1 **Supplemental Information**
2 **on**
3 **454-010 or 27H9612 OVERRIDER, WITH BOLT**
4 **AHY 100-4, MG TD, TF, BUGEYE SPRITE**

Unchromed pre-production sample on an NOS Healey 100 (left) and an NOS Sprite facebar (right).facebar.

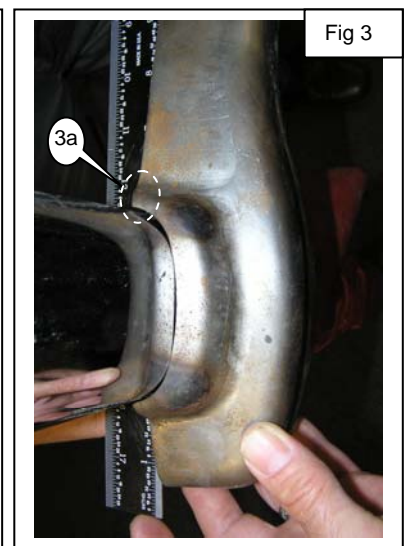
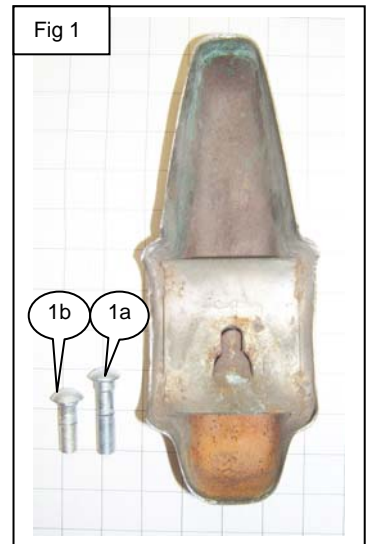
14 We originally produced the 454-010 override with a captive nut welded to a plate
15 that was in turn welded to the override. In production, the plate was difficult to
16 position perfectly and the angle of the installed override depended on exactly where
17 the captive nut was and the precise angle of the facebar. If the facebar was canted
18 the least little bit, the override leaned either forward or backwards. It was a lot more
19 noticeable with the override than the facebar. Because the nut was fixed in place,
20 there was not a lot that could be done. As we tried to come up with a fixture that
21 could be used in production to properly locate the captive nut, we found that an
22 override that fit a T Series facebar just fine could not be fitted to a Sprite or a
23 Healey. At that point we abandoned the idea of a captive nut and we started over.

25 Roger Moment loaned us an original sample of an override off a Healey 100-4 (Fig
26 1). The mounting plate has a slot which accepts and traps the head of a carriage bolt.
27 While both bolts are 7/16-20, the bolt used to in the rear of the 100-4 (1a), was longer
28 than the bolt used in the front (1b).
29

30 We found that the slot provided a wide range of
31 adjustment. Although the bolt did not move, you could
32 move the override up or down quite a bit and tighten
33 the nut when you were happy with the way it fit. We
34 decided to re-tool the override using the slotted
35 mounting plate. We also reshaped the curved edges
36 (2a) to more closely follow the facebar.
37

38 In June 2007 we received our first unchromed pre-
39 production samples of the new overrides. We fitted the
40 samples on an original Healey facebar (Fig 2) and an
41 original Sprite facebar (Fig 3) without the override
42 packing (400-418) so we could better judge the fit. We
43 also fitted them to the facebar on the Moss TD "pickup"
44 and a selection of replacement facebars. The sample
45 overrides could be installed on a Sprite, MG TD, and a
46 Healey 100 without any trouble using a 3/8" carriage
47 bolt 2 inches long.

49 The newly retooled overrides and pressed from steel plate, and the edges are cleaned
50 up by hand. The plates with the slot for the carriage bolt are pressed separately. The
51 outer shell and the plates are assembled in a fixture that precisely locates the plate, and
52 the two pieces are welded together. The override is chrome plated, and the back of the
53 override is painted silver, which is how all bumpers and overrides were done by the
54 factory. In September of 2007 we received our first shipment of the redesigned 454-010
55 overrides. We test fit them again, just to confirm that nothing had changed (and they
56 still fit fine). The correct bolts for the Healey would be 7/16 UNF (20 TPI), and we do not
57 have a source at this time, and we are not certain that the bolts used on the Healey
58 would be correct for the MG TD & TF or the Sprite, which used a 3/8" UNF bolt. The
59 overrides are supplied with one somewhat generic 3/8" UNC (16 TPI) x 2" carriage

60 bolt. If you are fitting these to the front facebar on a 100-4, the carriage bolt supplied
61 may be too long and it may show behind the facebar. If so, it can be shortened. There is
62 a slight difference in the shape of the rear edge of the override where it meets the top
63 of the face bar. On ours, the back edge (3a,5a) runs from the top to the facebar in
64 nearly a straight line, and on the Healey at least, these edges angled forwards a bit
65 near the face bar. We have tried to balance the features of original Sprite, T-series and
66 Healey overrides while designing something that was practical to make.
